AIR PRODUCTS INC. (WEMBLY RD.) #90-54
(HELMER) SITE PLAN *Approved* 93-91

SUBJECT: AIR PRODUCTS SITE PLAN
NEW WINDSOR PLANNING BOARD 90-54

SUBJECT: AIR PRODUCTS SITE PLAN (90-54)
SITE PLAN COMPLETION REVIEW 7/14/92

AIR PRODUCTS SITE PLAN (90-54) WEMBLY ROAD

TOWN OF NEW WINDSOR, N.Y. SITE PLAN
PLANNING BOARD APPROVED AND RECOMMENDED FOR THE BOARD
ON SEP-3-1991
BY RONALD LANCER, SECRETARY
APPROVED BY THE BUREAU OF FIRE PREVENTION
TOWN OF NEW WINDSOR, N.Y.
DATE: 6-14-1991

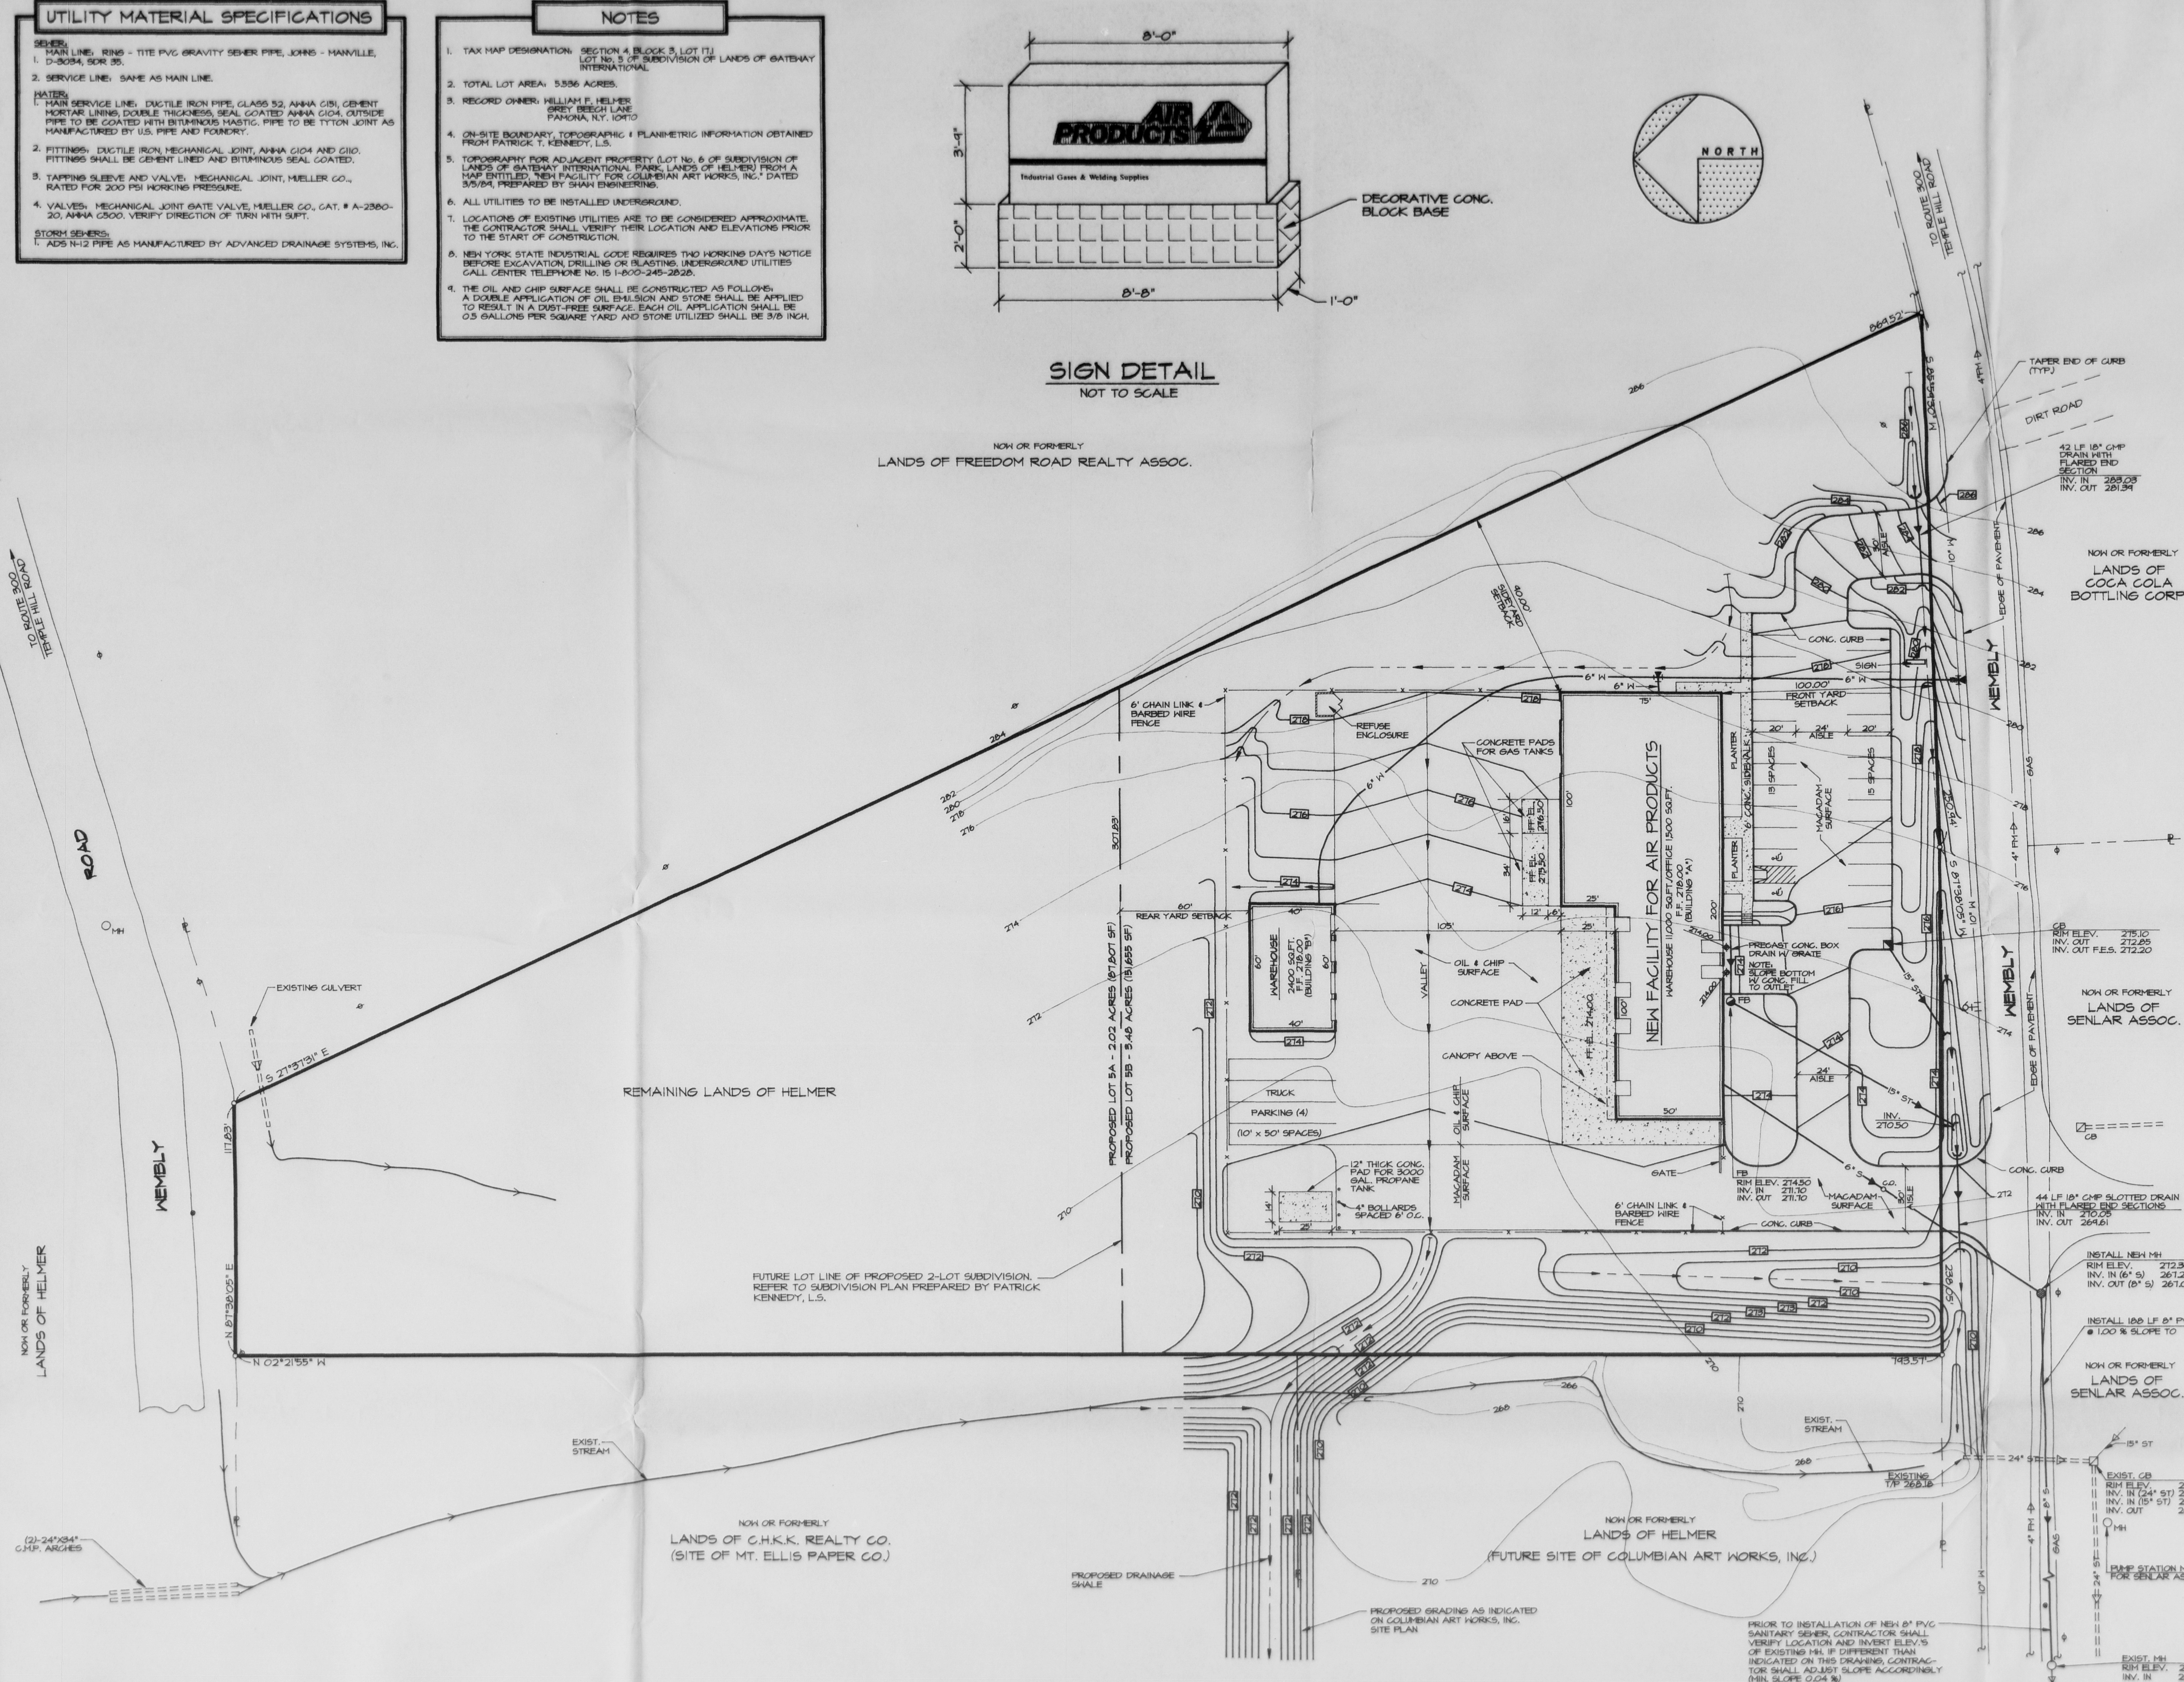
MR. EDSALL: Can we ask kind of a basic question. The front yard setback requires 100. Why would you want to provide 99?

MR. VAN LEEUWEN: In the front of it seems to be quite a concern about the drainage and I have heard several people talking about some problems. I want to look at the drainage where it is going, where it should be, how far we want to push this along to get the drainage work done.

MR. EDSALL: Now, the town for the record is receiving complaints from the people that have occupied the previous site plans that the drainage is unacceptable. So, just passing it on.

This plan is acceptable conditional on vehicle protection for the Liquid Propane tank area and around the concrete pads for the gas tanks.

MR. SHAW: That's one of the beauties of computerated drafting, as I'm sure you are aware and that's why we call this a sketch drawing and not a final drawing, trust me it will be 100 when the final drawing comes out.
